Docket Item # 2
BAR CASE # 2015-00207

BAR Meeting
July 15, 2015

ISSUE: Re-approval of a Certificate of Appropriateness for Alterations

APPLICANT: 1124 Prince Street

Existing Conditions – Rear Elevation

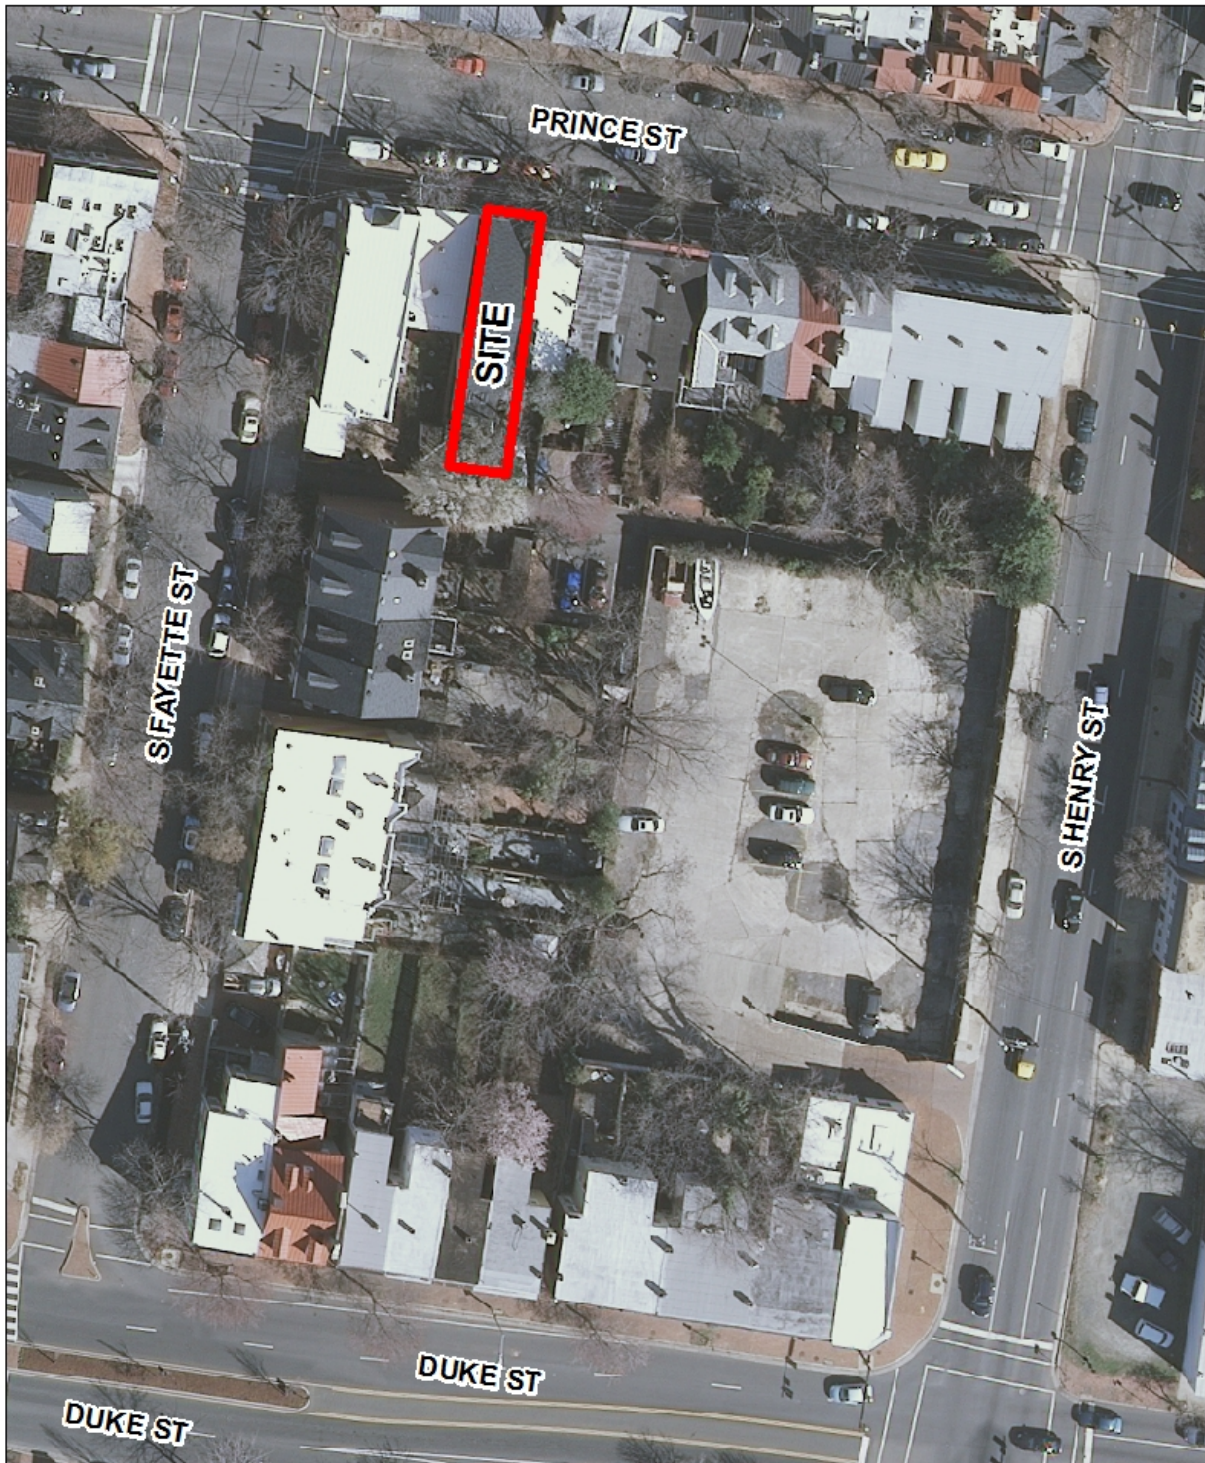
The applicant is requesting a re-approval to replace the non-historic, German profile, Masonite siding with HardiePlank clapboards and the existing windows with fiberglass insert windows on the east (horse alley) and south elevations of the ell and the sunroom primarily for maintenance purposes. The applicant currently has an active approval from the Board for the replacement of the Masonite siding on the west (side) elevation (BAR#2014-0413 on 1/7/15.)

While it is not normal to approve synthetic materials of any kind on the historic portion of a structure, in some specific circumstances, such as adjacent to narrow horse alleys where there is poor air circulation and the siding is difficult to maintain, or on minimally visible secondary elevations, the Board has approved their use on a case-by-case basis, especially if no historic fabric remains. In this particular case, the mid/late 20th century renovations have left this building without any exterior historic fabric and a modified building form. Staff believes that these changes have impacted the resource’s integrity and altered its period of significance. Additionally, the new, modern materials will be installed on the secondary elevations and in a horse alley, and will be minimally visible from the right-of-way.

Staff finds the use of the fiber cement siding and fiberglass windows in conformance with the Board’s *Fiber Cement* and *Window Policies* and recommends re-approval of the Certificate of Appropriateness, as submitted.
